# Request for Quotation

RFQ NUMBER  
**PRS09021**

**Security Bollard System  
Remote Controlled and Manually Removable**

### Addendum #02

# Ram Bollard

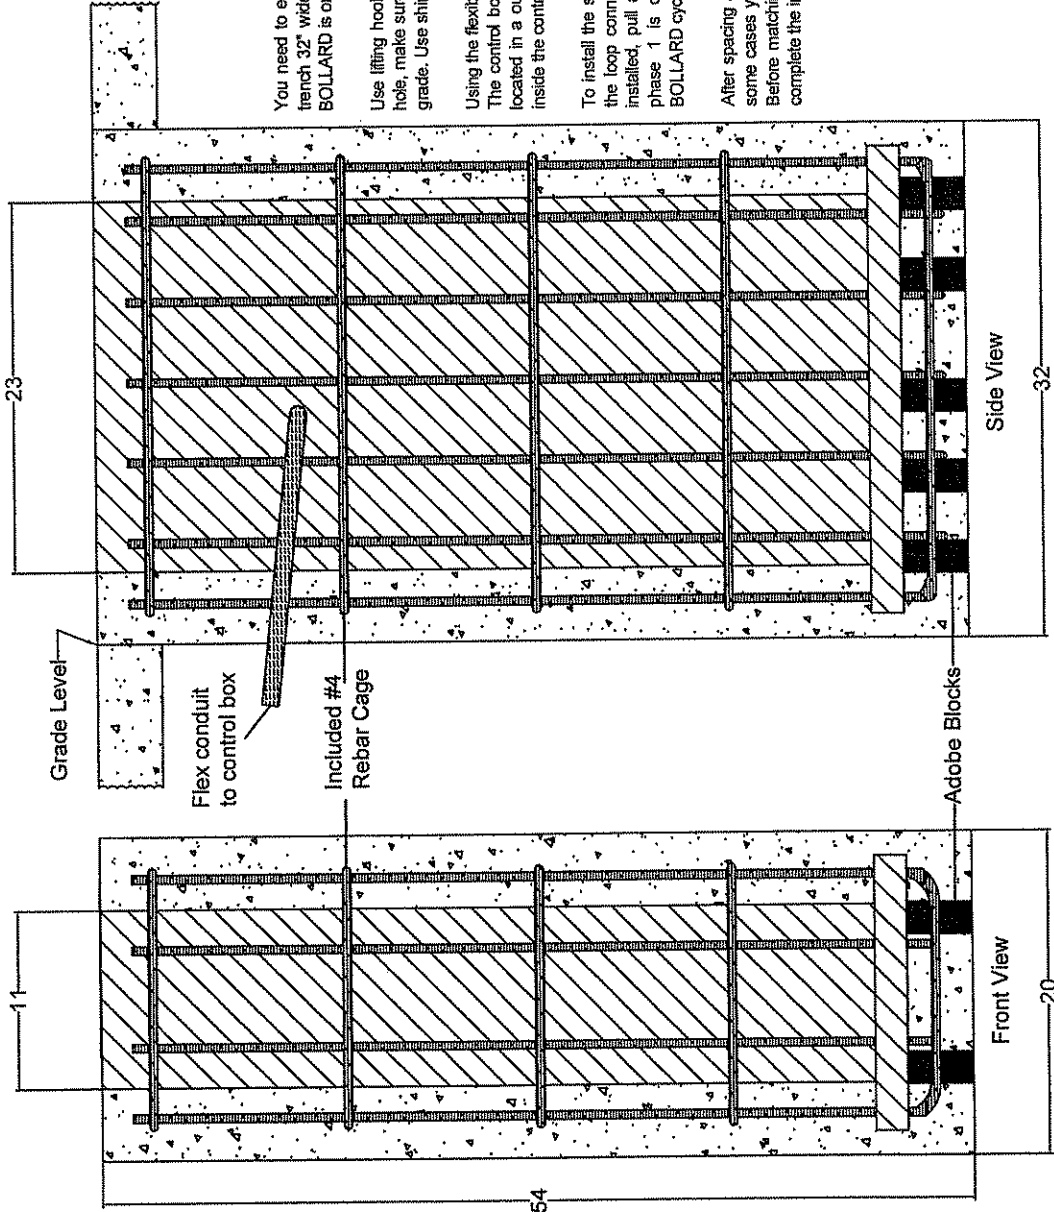
- **7.1 Bollards - The system shall consist of 21 retractable and 3 removable bollards – removable bollards shall match the retractable bollards in all aspects, except for the base configuration difference between the retractable and removable**
- **7.4 General Construction – see additional drawings attached**

# Bobcat Bollard 6 1/2" Diameter

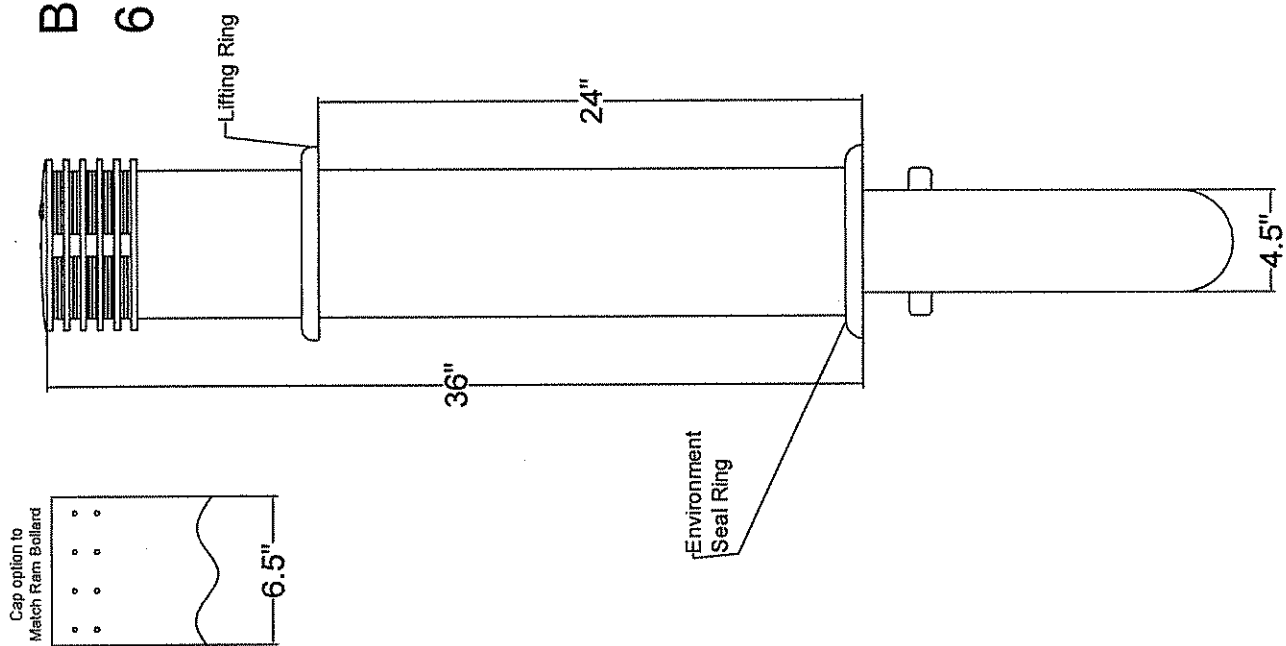
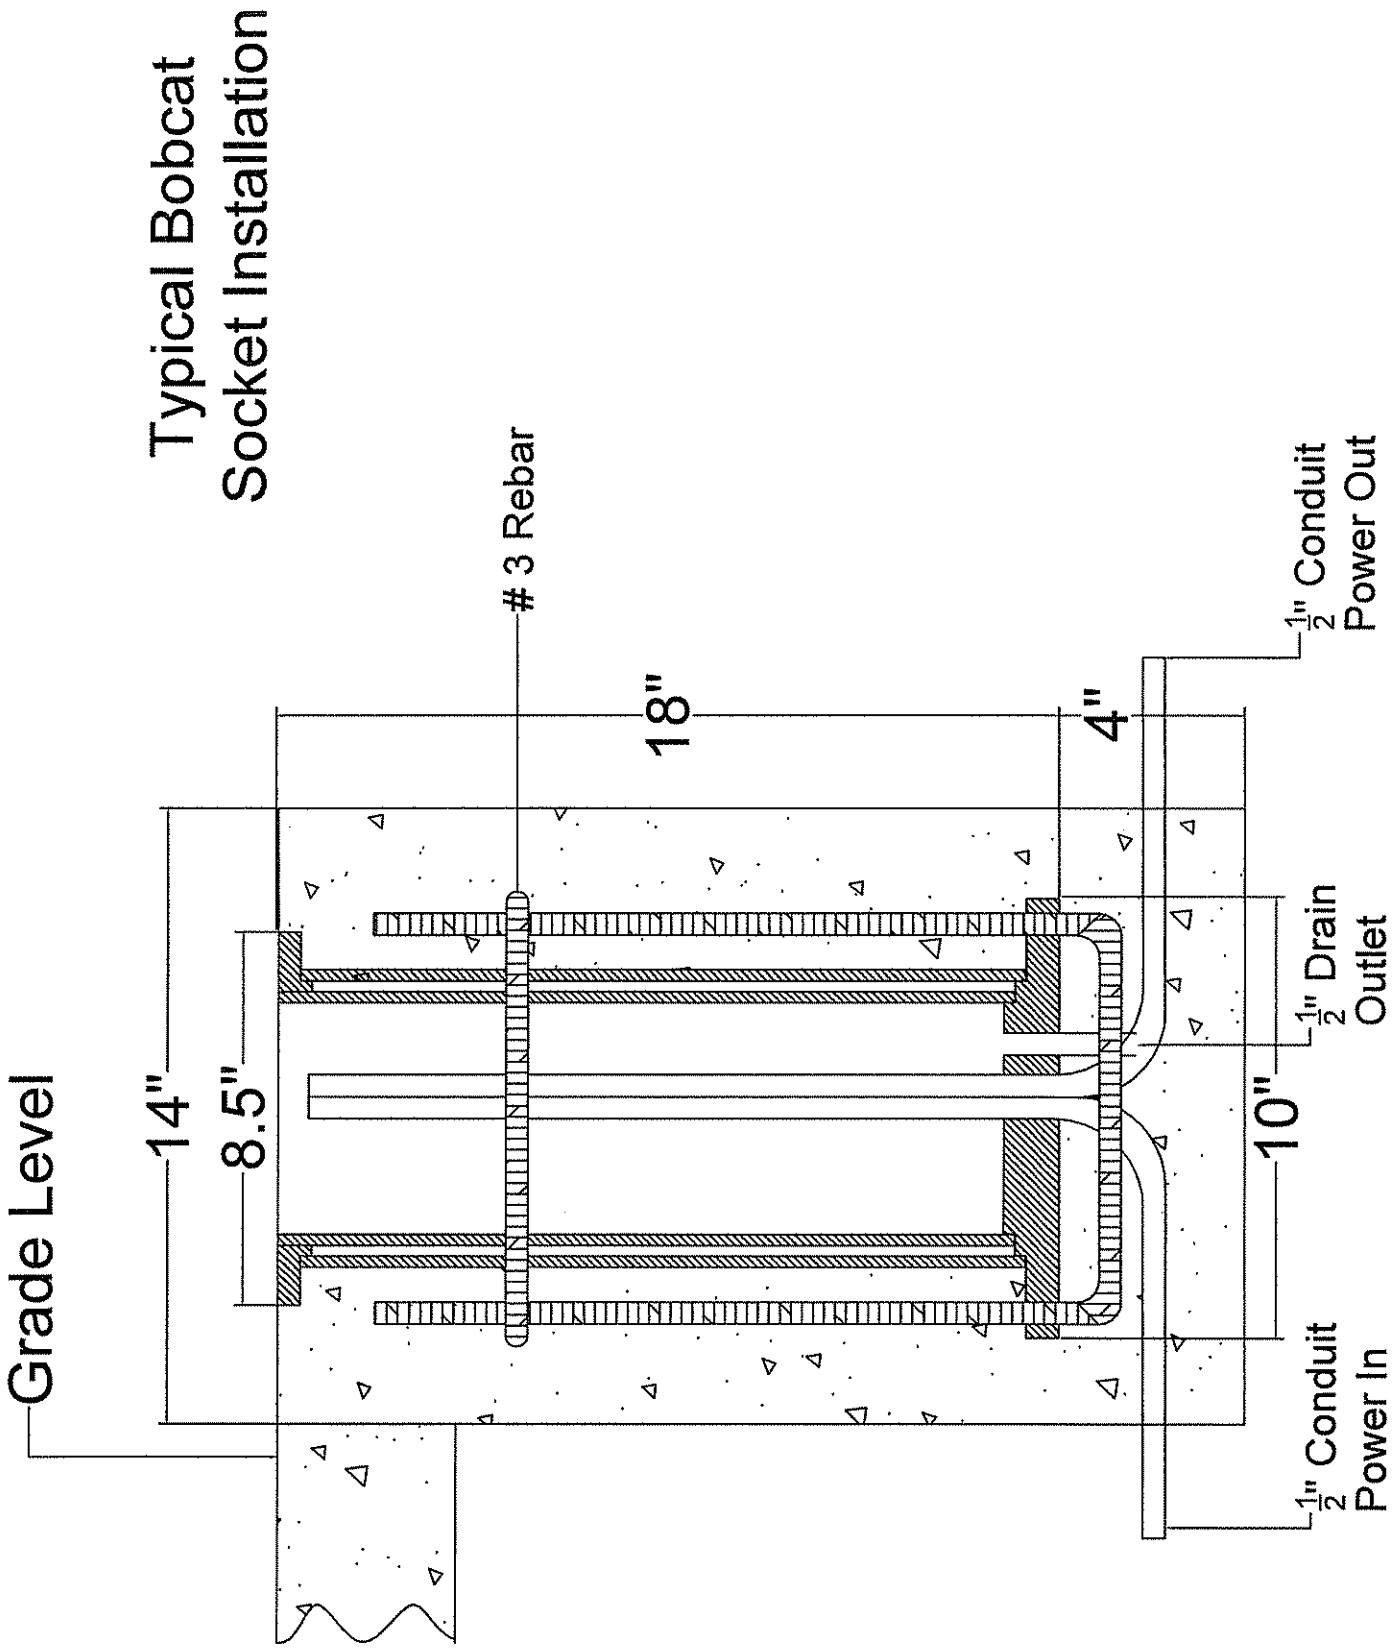
- **Removable bollards have sockets that shall be 18” deep**
- **Excess dirt shall be left around excavated areas for settling purposes – excavated areas shall be compacted where applicable, leaving 6 inches of loose material for seeding purposes**
- **All dirt excavated areas shall be dressed back to original contour, seeded, and straw added two layers thick. Grass seed shall be used that is the same as the existing grass in the area**

WEST VIRGINIA STATE CAPITOL DIRECTORY

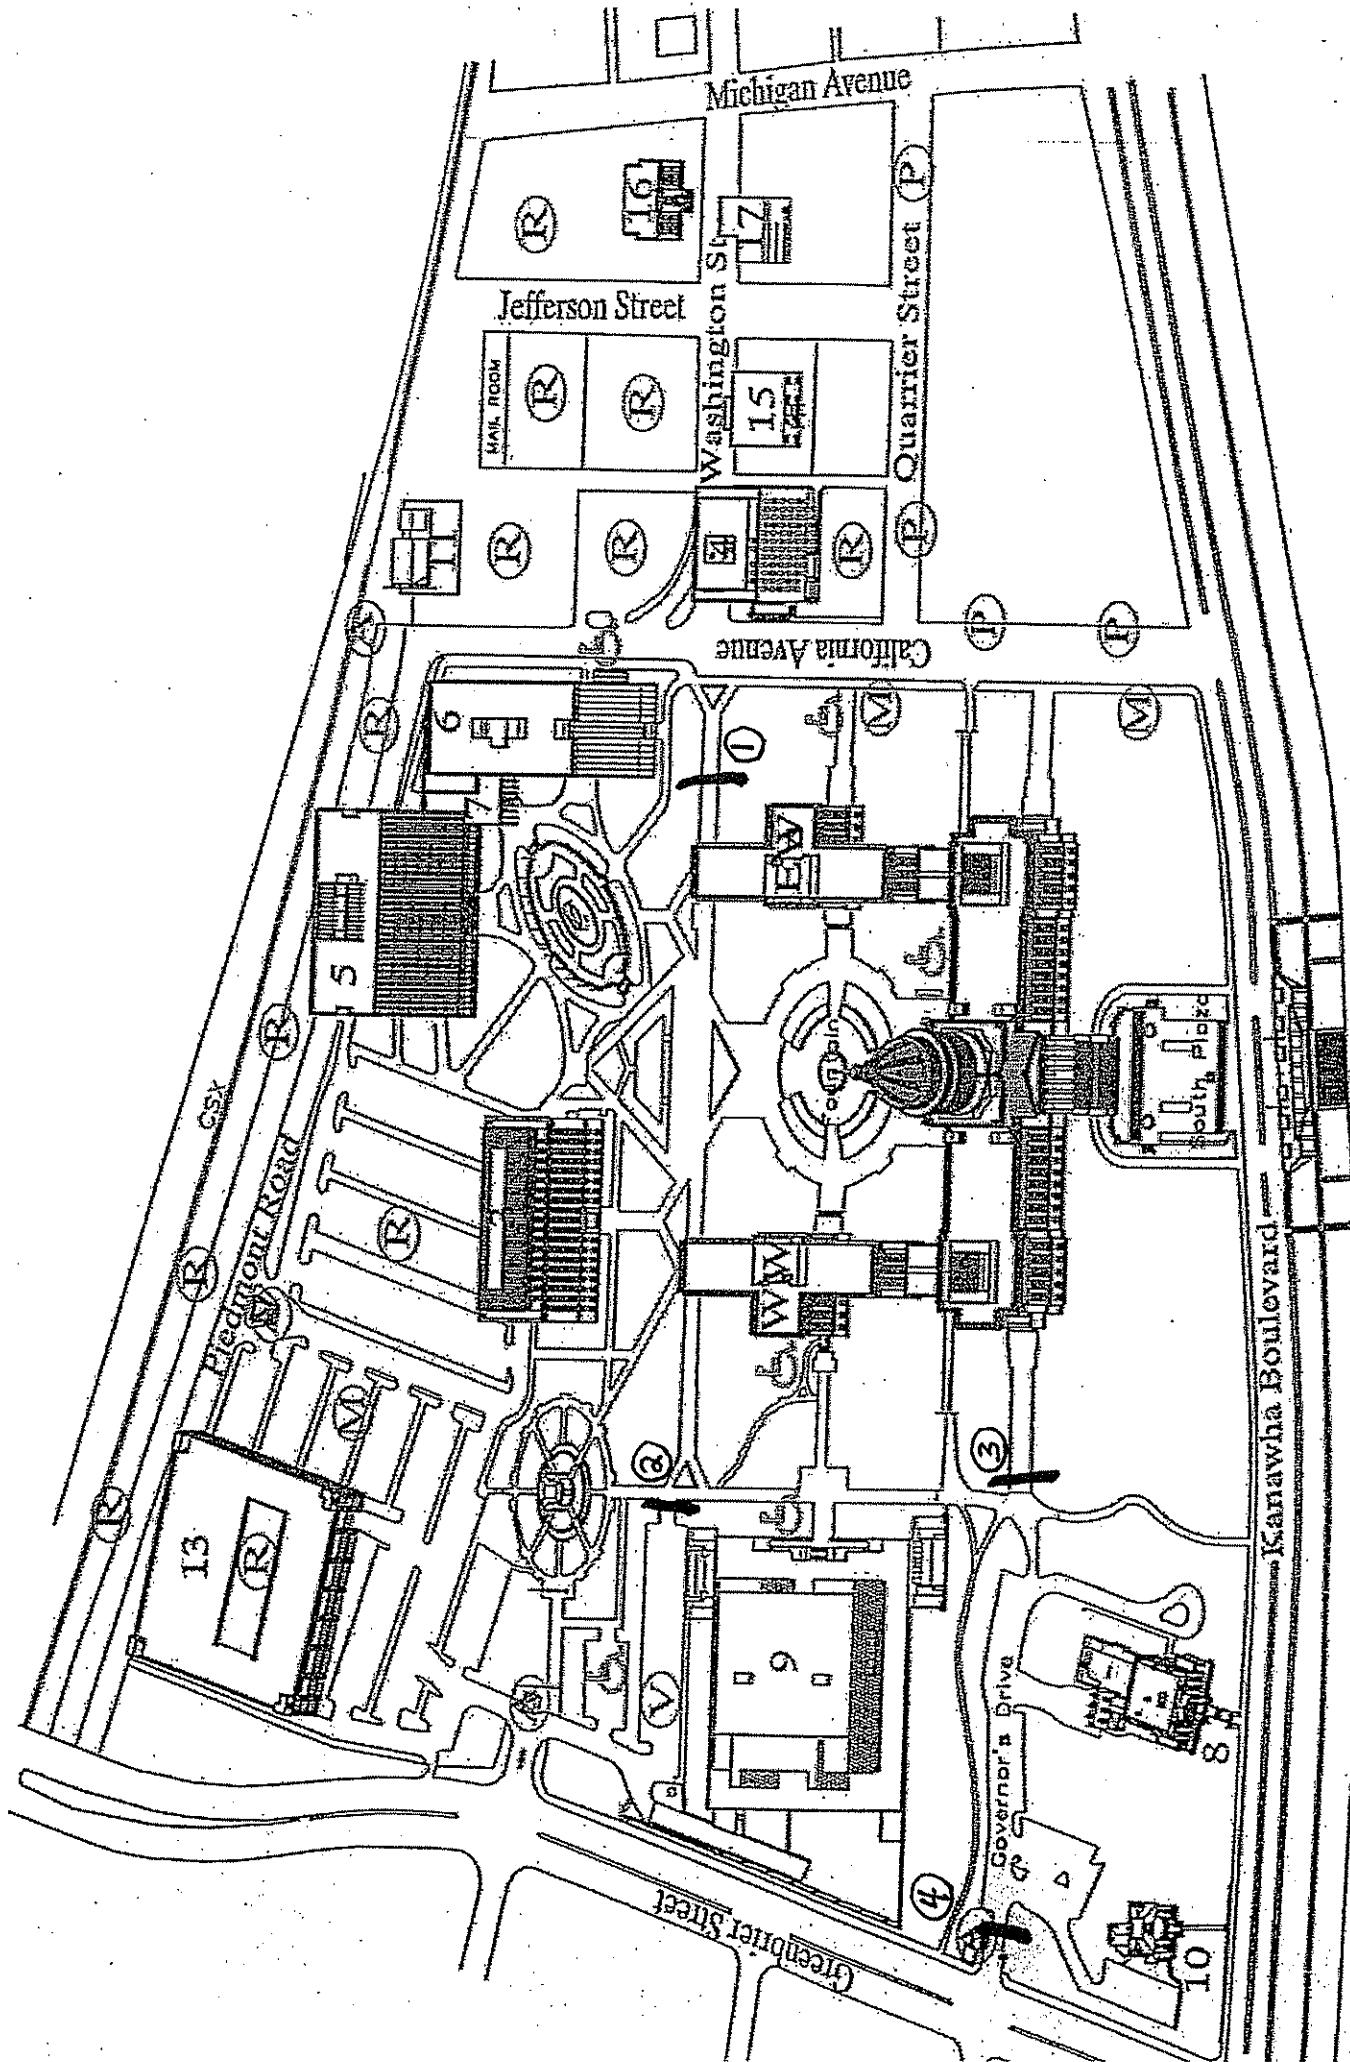
- Paragraph 2: Four locations have been identified on the attached campus map – Location 1: Bollards shall be 3 retractable units working as one system, off center, and 3 removable, opposite side; Location 2 shall be 6 retractable units working as one system; Location 3 shall be 6 retractable units: 3 units working as one system, and 3 units working as one system; Location 4 shall be 6 retractable units: 3 units working as one system, and 3 units working as one system - (total is 21 retractable and 3 removable)
